## VARIANCE REQUEST

Iowa Department of Natural Resources

13. Decision: *approved*  
Date: *1/5/05*  
14. Appeal:  
Date:

RE: Wastewater Disposal Improvements  
Palmer, Iowa

## **COLLECTION SYSTEM PLAN**

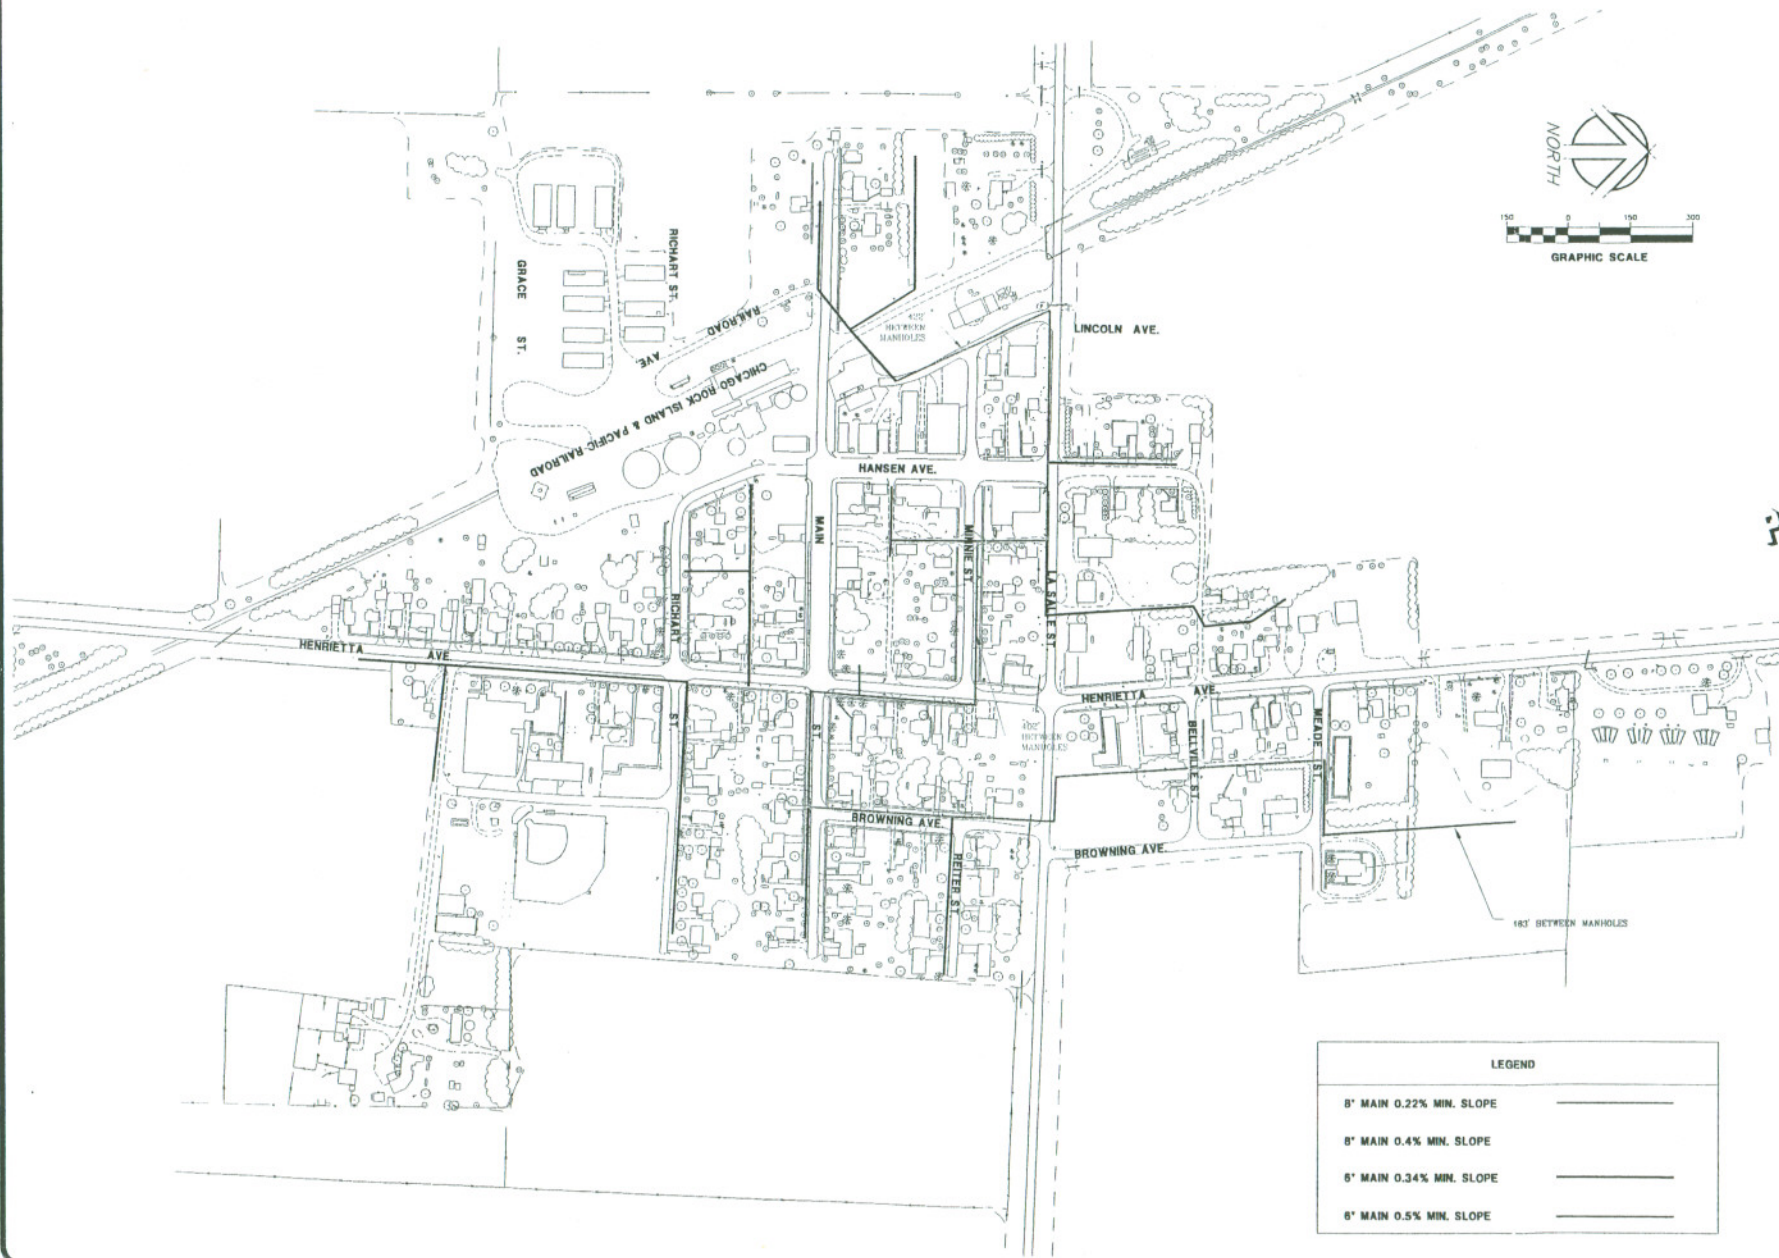
1. Chapter 12.5.3: Request to allow a minimum slope of 0.5% on all 6" diameter mains with exception of those discussed later in this letter with requested slopes of 0.34% for 6" and 0.22% for 8". These mains are shown on drawing SA-01. Estimated cost savings in surface replacement only is \$900. Additional savings would be realized in trenching depth for the pipe.
2. Chapter 12.5.7.1.d: Request to increase manhole spacing in three locations to greater than 400'. These areas have been identified on Sheet SA-01 and show the manhole spacing to be 463', 402', and 422'. In all situations the sewer main must be located at the proposed distance for services and an additional manhole is a construction cost that can be avoided if proper cleaning equipment is available.

3. Chapter 12.5.3.b: Request two sewer main runs be designed at grades of 0.34% and 0.22% for 6" and 8" diameter pipe respectively. These runs are identified on sheet SA-01. Copies of written assurances stating any additional sewer maintenance required by reduced slopes will be provided have been included with this request and originals have been sent to your office from the City.

Chapter 12.5.3.b indicates that if a lift station can be eliminated as well as substantial cost savings realized, sewers may be designed at the previously stated slopes, which is applicable in this situation. These requested slopes should provide adequate service from the service connection to the pump station. Additional maintenance is readily available from T&L Cleaning as previously mentioned. Estimated cost savings is \$12,500 for the pump station and backup power that would not be necessary. Additional savings would be realized in the pipe trenching depth.
